STATE CANCER INSTITUTE, GUWAHATI - PHASE-2

HOSPITAL BLOCK			
DSGN

**FIRST FLOOR PLAN - PART:**

DRAWING NO. 019035 - A - HP - 02 - ID - 0023

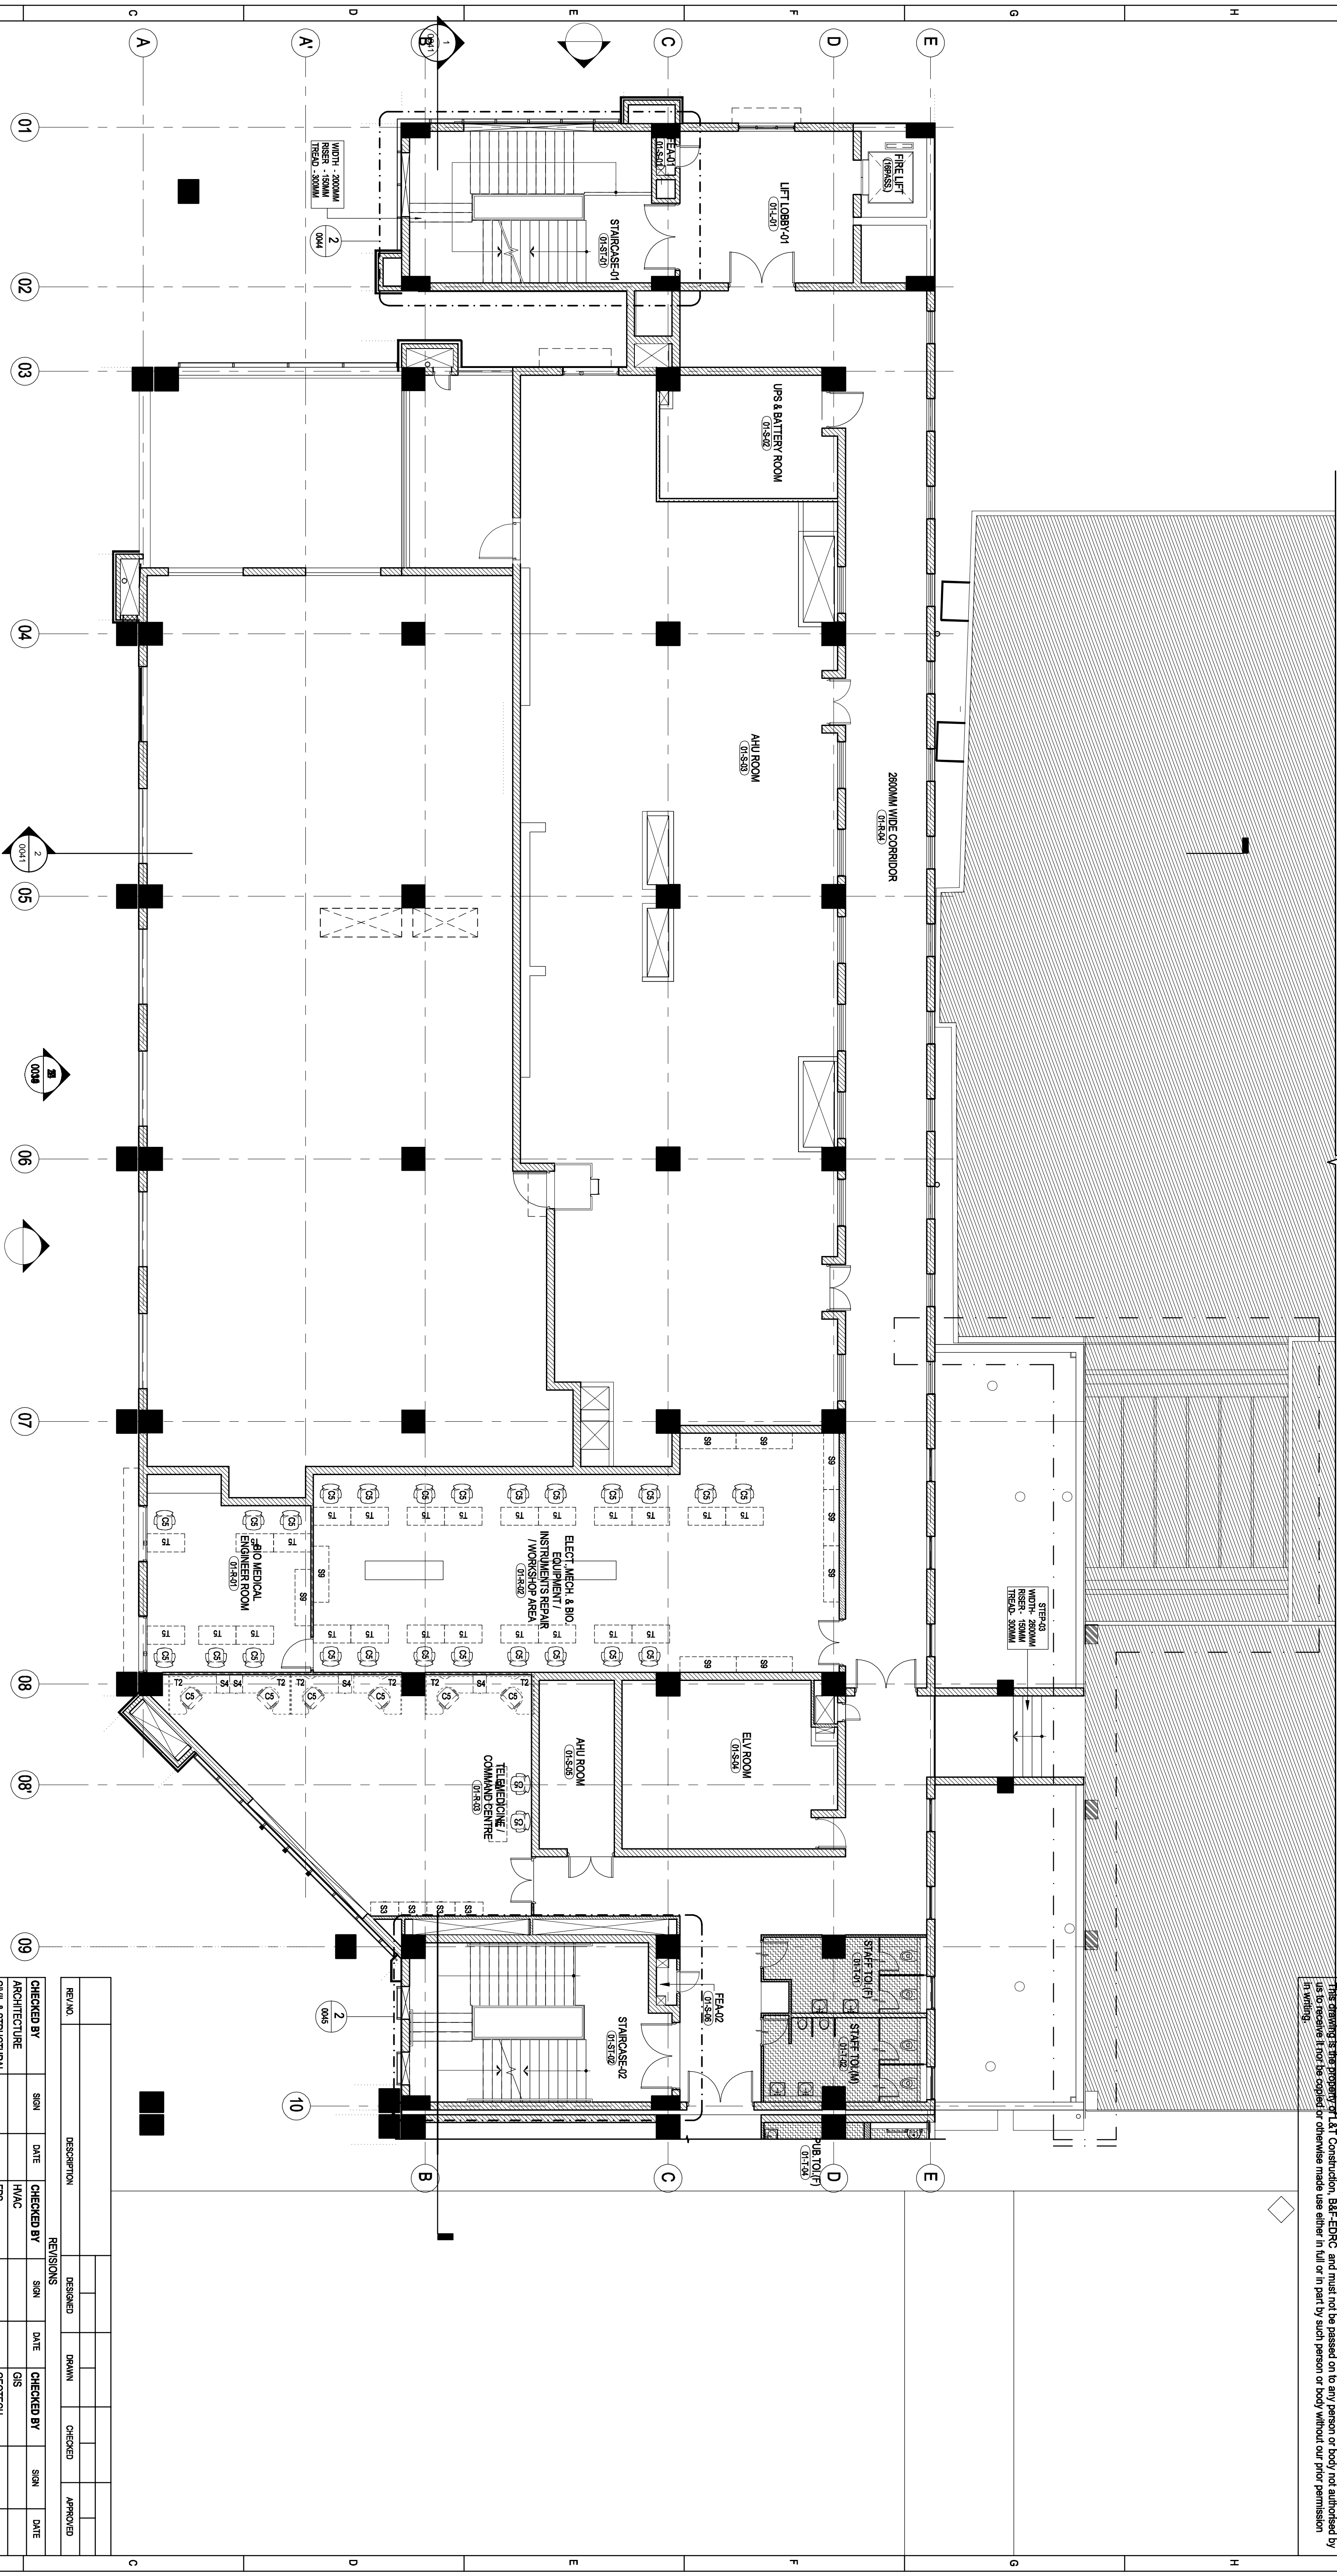
FURNITURE MARKUPS		
CHKD
